Diagnostic Trouble Codes (DTCs), Low Oil Pressure
CXU, GU, LEU, MRU
MP7 US2010, OBD2013, US2014, OBD2015

FSB 221-010, Diagnostic Trouble Codes (DTCs), Low Oil Pressure

(May 2016)

W2084376

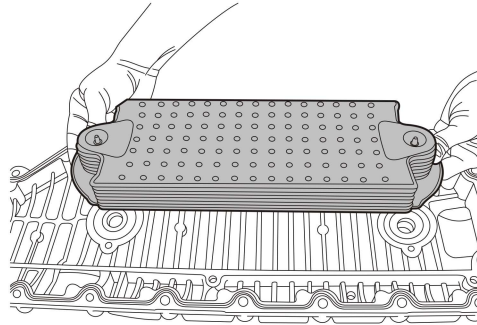
If there are no obvious signs of oil dilution, replace the pressure reduction valve, oil cooler and piston cooling nozzles using the procedure below. Also reprogram the engine control module if required based on the table below.

Required Parts			
Item	Part Number	Description	Quantity
3	469846	O-Ring, Internal	1
4	22416685	Pressure Reduction (Relief) Valve, Purple	1

W2103580

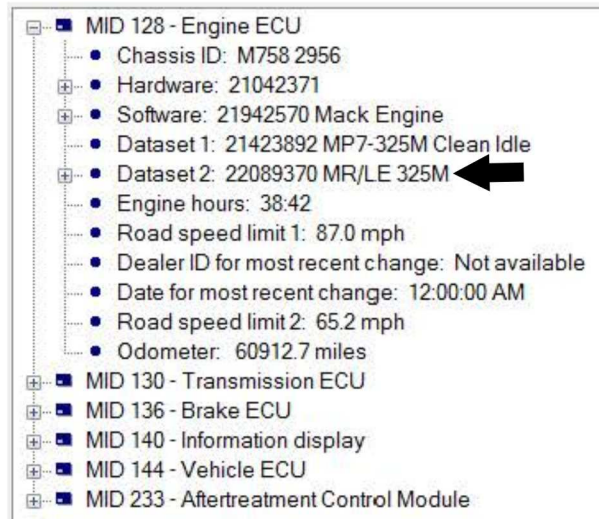
- 5 Remove and replace the piston cooling nozzles. Refer to Function Group 22. Replace the single use screws. Tighten the new screws to 24 ± 3 Nm (18 ± 2 ft-lb).
- 6 Remove and replace the oil cooler. Refer to Function Group 223.
- 7 Install the oil pan. Refer to Function Group 21.
- 8 Refill the engine oil to the proper level.
- 9 Reconnect all previously removed cables to the negative (ground) battery terminals.
- 10 Reprogram the engine control module if required based on the reference table. Refer to Function Group 28.
- 11 Start engine, check for leaks and proper operation. Clear any DTC.

Item	Part Number	Description	Quantity
2	994445	M8*16 Piston Cooling Nozzle Screws	6
3	22577447	Piston Cooling Nozzle	6

W2082023

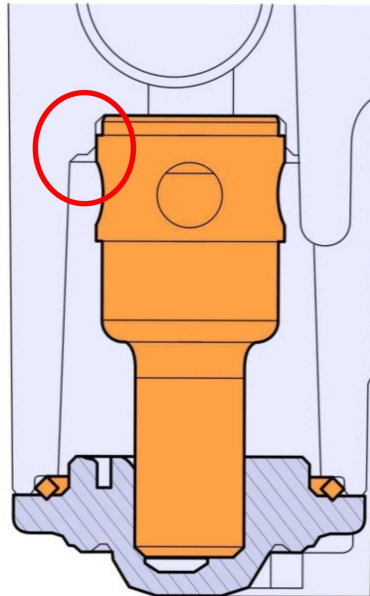
- 1 Secure the vehicle for service by parking it on a flat level surface, applying the parking brake, chocking the rear wheels, and placing the transmission in neutral or park.
- 2 Disconnect all battery cables from the negative (ground) battery terminals to prevent personal injury from electrical shock and prevent damage to electrical components.
- 3 Remove the oil pan. Refer to Function Group 21.
- 4 Remove and replace the pressure reduction (relief) valve in the oil valve body and replace the internal O-ring. Tighten cover fasteners to 10 ± 2 Nm (88 ± 17 in-lbs).

Note: Make sure the valve is fully seated and the cover close to the valve housing prior to threading in the retaining screws. Otherwise the valve can make contact with the edge just ahead of the seating surface and damage the valve. Do not use power tools to install this valve. Do **NOT** disturb the pressure reduction valve located in the oil filter housing.
